SYDNEY NORTH PLANNING PANEL (SNPP)

PANEL REFERENCE:	2017SNH043
DA NUMBER:	MOD2017/0080
LOCAL GOVERNMENT AREA:	City of Ryde
PROPOSED DEVELOPMENT:	S96 (2) Modification Application to Stages 2 and 3 of the Shepherd's Bay redevelopment including the provision of 45 additional dwellings within the approved building envelope, relocation of community facility, residential gymnasium, increase of commercial floor space, 33 additional car parking spaces and associated alterations.
STREET ADDRESS:	6-18 Nancarrow Avenue, 9-11 Rothesay Avenue and 41 Belmore Street, Ryde.
APPLICANT:	Shepherds Bay Urban Development Pty Ltd
NUMBER OF SUBMISSIONS:	1 submission
REGIONAL DEVELOPMENT CRITERIA (SCHEDULE 4A OF THE ACT):	Capital Investment Value (CIV) for original application exceeded \$20 million.
LIST OF ALL RELEVANT S79C(1)(a) MATTERS:	Environmental Planning and Assessment Act, 1979 State Environmental Planning Policy No 55 – Remediation of Land (SEPP 55) State Environmental Planning Policy No 65 – Design Quality of Residential Apartment Buildings (SEPP 65); State Environmental Planning Policy (Building Sustainability Index: BASIX) 2004 (BASIX); Deemed State Environmental Planning Policy Plan Sydney

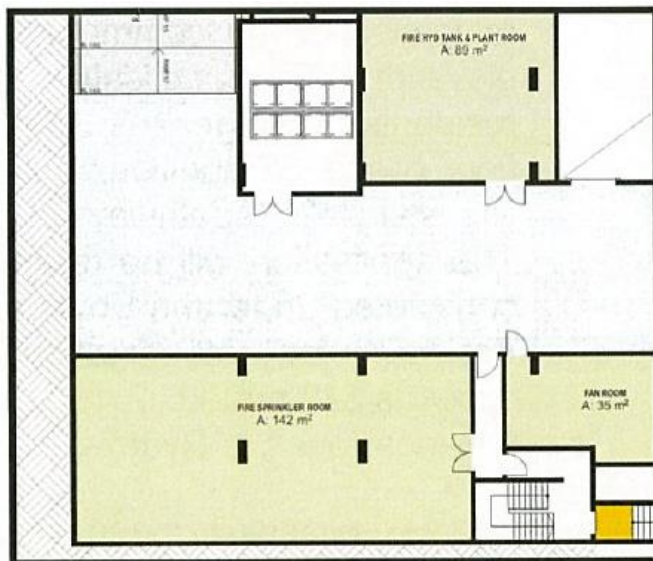
The car parking configuration has been reviewed by Council’s Senior Coordinator Development Engineers who has provided the following comments:

A review of the revised layout with respect to the requirements of AS 2890.1 are noted as follows:

- *The plans have expanded a bin room located on the inside corner of the main vehicle entry to the basement garage. Under the original approval (left figure below) the room was setback from the ramp and provided a splayed corner.*

Noting that the works for Stages 2 & 3 are currently well underway and this element has likely been constructed, it is advised that centreline markings be implemented in the access aisle on approach to the corner to prevent conflicting flows and the walls of the bin room be modified to provide visual permeability between conflicting vehicle flows.

- There are 21 sets of tandem parking spaces provided. As noted in the original consent, this will warrant that each set of tandem parking to be allocated to a single unit. With the revised proposal accommodating 18 lots of 3 bedroom units, 3 sets of the 2 bedroom units would also need to be allocated a set. With a total of 210 lots of 2 bedroom units, this presents as a relatively minor difference and is tolerable.*

- The proposed retail area is noted to have a pedestrian entry to the basement which opens up at a corner at the base of the ramp connecting the upper basement parking level with the lower ground level. Due to the number of vehicle conflict points in this location, it is warranted that a pedestrian path be linemarked along the southern side of the access aisle to guide pedestrians clear of vehicle swept paths and provide pedestrian awareness for drivers approaching this location. This is addressed in the revised condition 30.*

- a) To facilitate vehicle access and sight distance at the corner located on Basement Level adjoining a waste bin room (opposite the Fire Sprinkler Room), **a convex mirror shall be installed diagonally opposite the bin room.** ~~the wall of the bin room must provide a splay of minimum 2m by 2m dimensions on the corner and centreline line marking on both approach directions to the corner, to ensure there is separation of conflicting vehicle flows. In the event that the splay cannot be provided due to construction of significant structural elements in this region (verified by a Structural Engineer), the walls of the waste bin room must be visually permeable in the region of the splay so as to maximise drivers sight distance to approaching traffic.~~

Condition 30(a) - It is understood that modifications to the corner of the waste bin room to provide a 2m x 2m splay cannot be undertaken due to the location of the structural column and garbage chutes. Further it is understood that the walls of the waste bin room cannot be made permeable due to fire safety reasons. In light of these structural design reasons, in addressing Council's concerns regarding the blind spot created by the corner of the waste bin room affecting visibility of approaching vehicles in the opposite direction, it has been previously recommended to Council by City Plan Services that the provision of a convex mirror be considered to improve sight distance at that location. This Practice supports such measures upon review of the plans and recommends that the convex mirror should be installed directly opposite the waste bin room and adjacent to the fire sprinkler room.

In addition to the above, it is recommended that a centreline marking is also proposed to be implemented to provide effective separation between two vehicles travelling in opposing directions in accordance with draft Consent Condition 30(a).
